DRAWING AMENDMENTS

REMARKS

Marked Drawing Showing Revisions

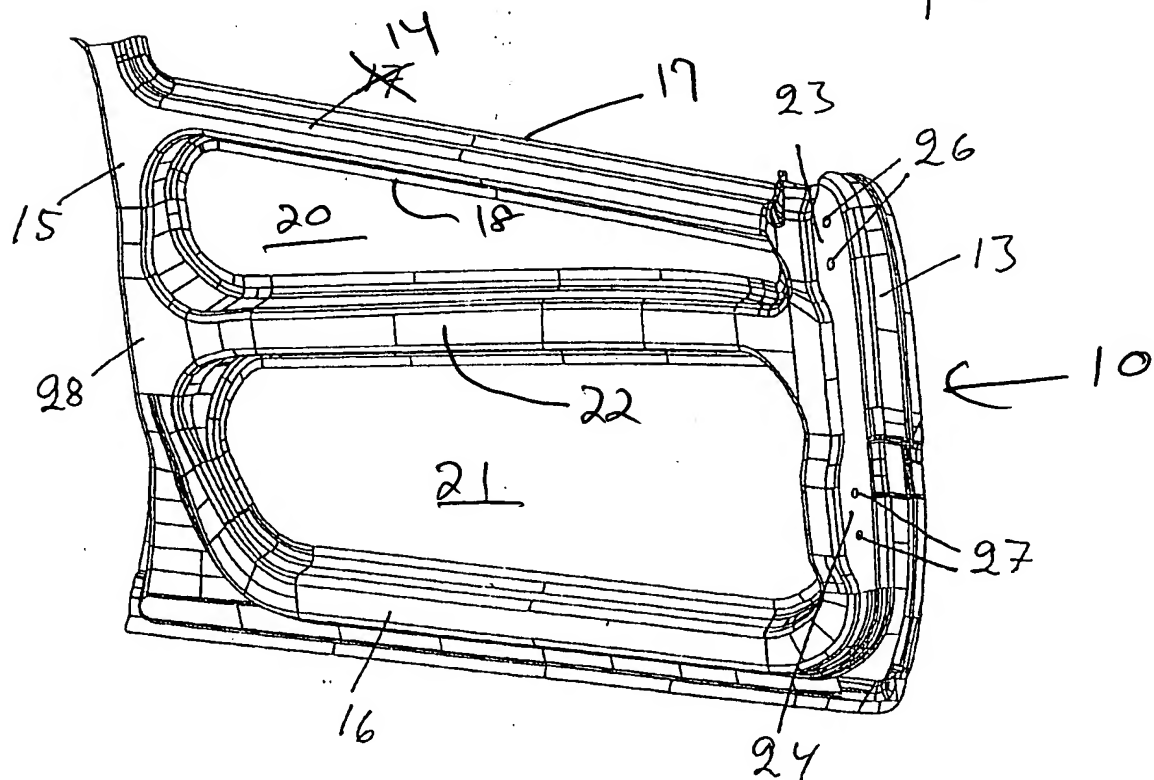
Applicant has revised some of the reference numerals identified at page 2, penultimate paragraph of the specification which discusses Figures 1 and 2 of the drawings, to conform to the reference numerals in the drawings. Additionally, some of the reference numerals in Figures 1 and 2 of the drawings have been revised to conform to the reference numerals used in the penultimate paragraph of page 2 of the Specification. Applicant respectfully submits that the reference numerals designated in the discussion of Figures 1 and 2 of the Specification (as amended herein) conforms to the reference numerals designated in Figures 1 and 2 of the drawings (as amended herein).

Applicant has also replaced reference numeral 28, which refers to the "outer panel" at the next to the last line of the last paragraph of page 2 of the Specification, with reference numeral 29. Additionally reference numeral 28 has been replaced with the reference numeral 29 in Figures 5 and 6 of the drawing to conform to the revision to the Specification. The reason for this change is that reference numeral 28 has already been used in the Specification and drawing to designate the region at which the rear end of the impact guard beam 22 joins the rear standing

hat beam 15 (See Figures 1 and 2 of the drawing and page 3, second full paragraph of the Specification).
